Subject: Minutes for 60th Protection Sub-Committee Meeting.

60th Protection Sub-Committee Meeting (26th May, 2025)-MoM

Minutes of
60th Meeting of Protection Sub-Committee (PSC) of
Northern Regional Power Committee

Date and time of meeting : 26.05.2025 10.30 Hrs.

DR of 220 KV Anta(NT)-Lalsote(RS) (end) (PG) Ckt-1

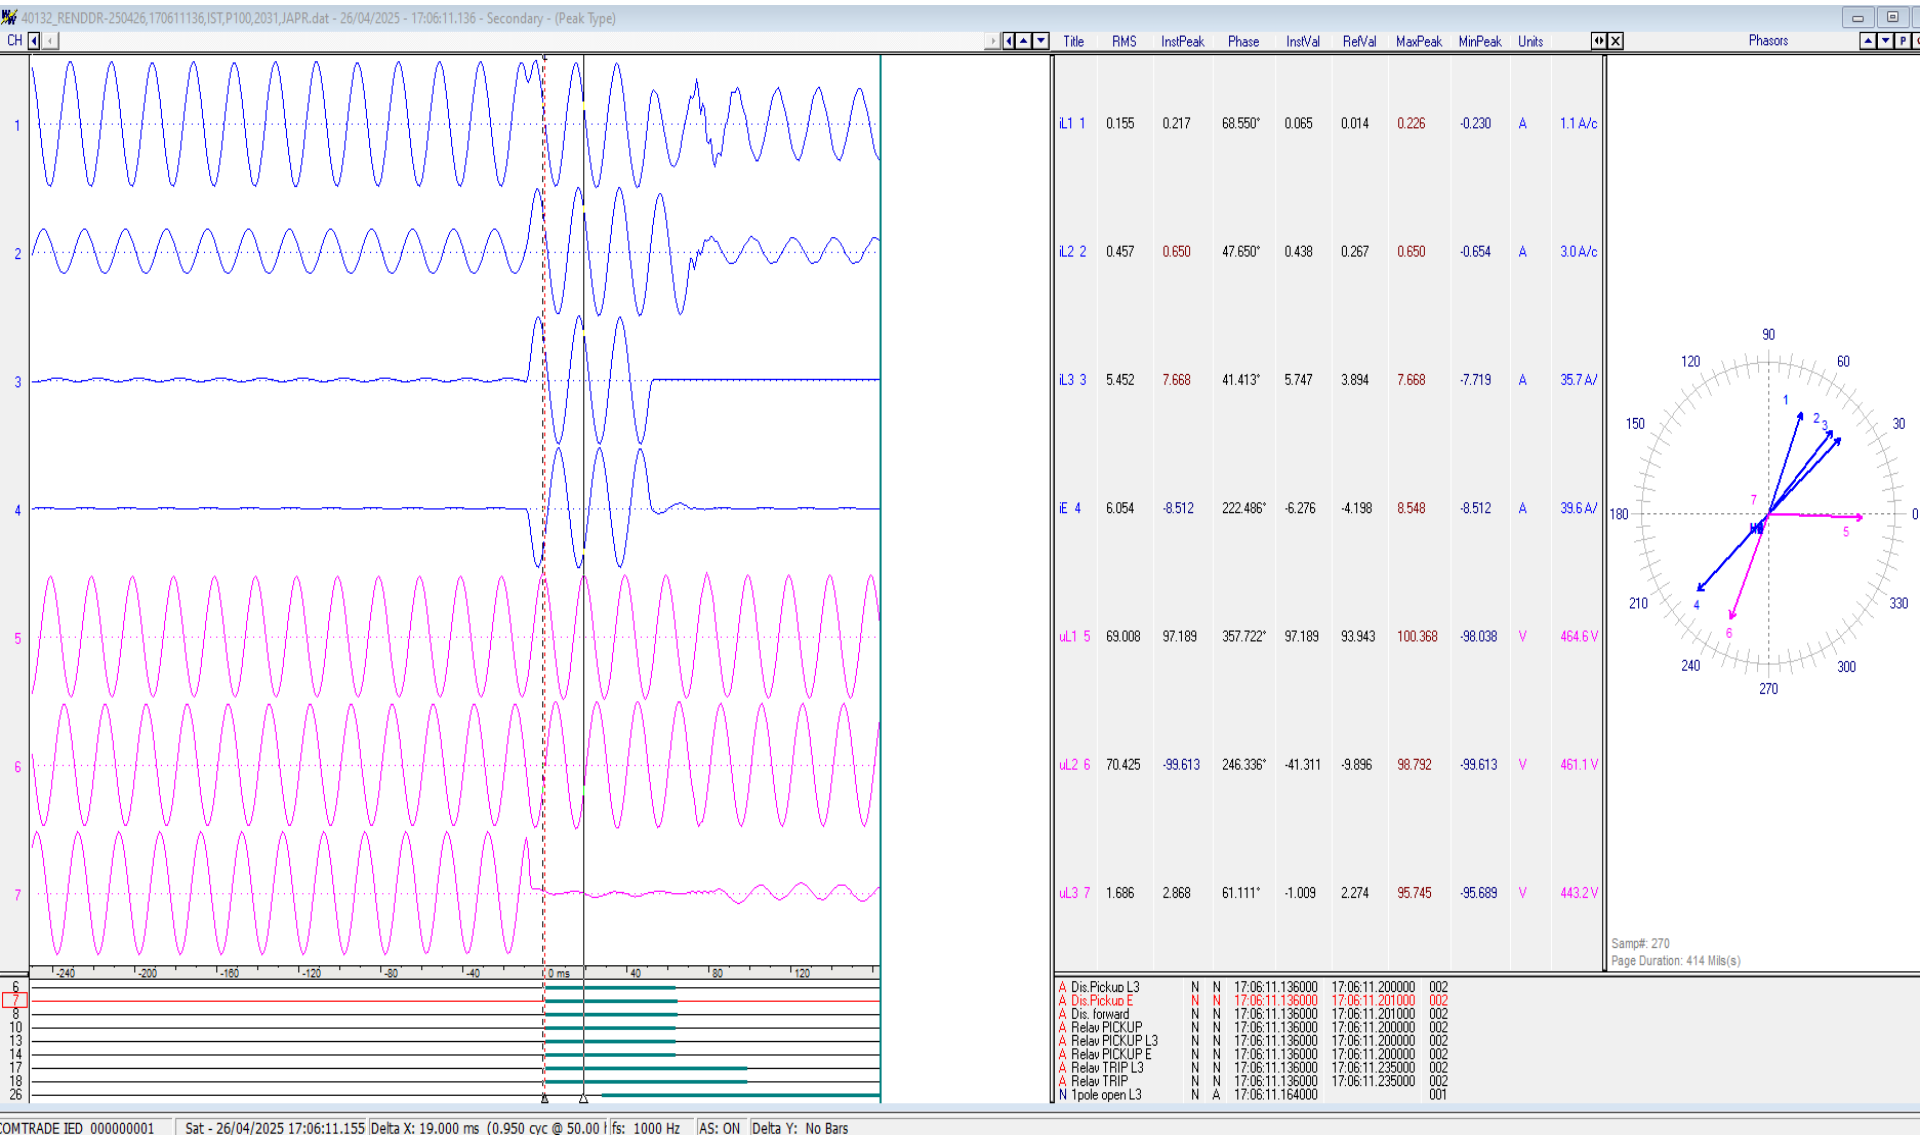
- ✓ B-N phase to earth fault; $I_b \approx 5.452 \text{ kA}$
- ✓ Fault clearing time $\approx 60 \text{ ms}$

DR of 220 KV Lalsote(RS)-Dausa(RS) (end) (PG) Ckt

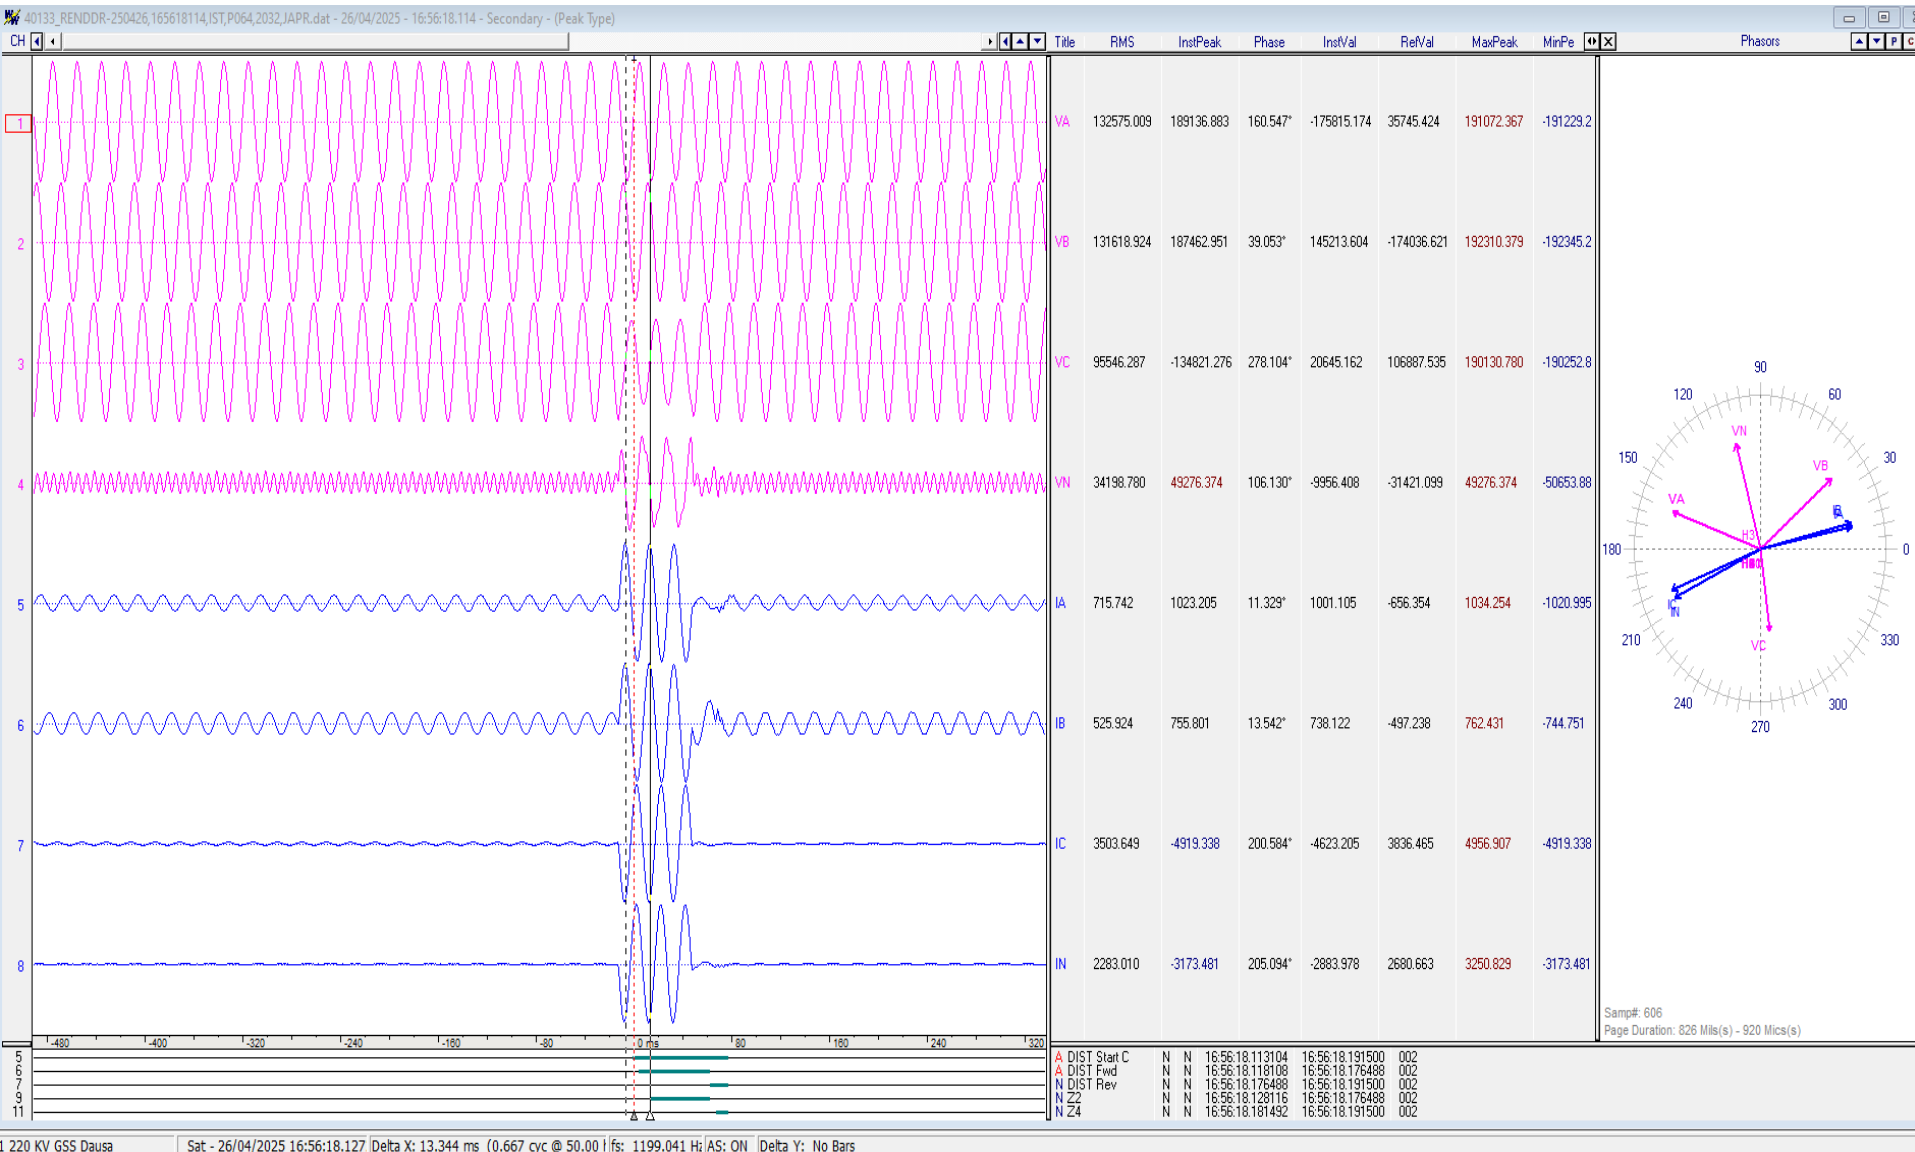
- ✓ B-N phase to earth fault; $I_b \approx 3.504 \text{ kA}$
- ✓ Fault clearing time $\approx 60 \text{ ms}$
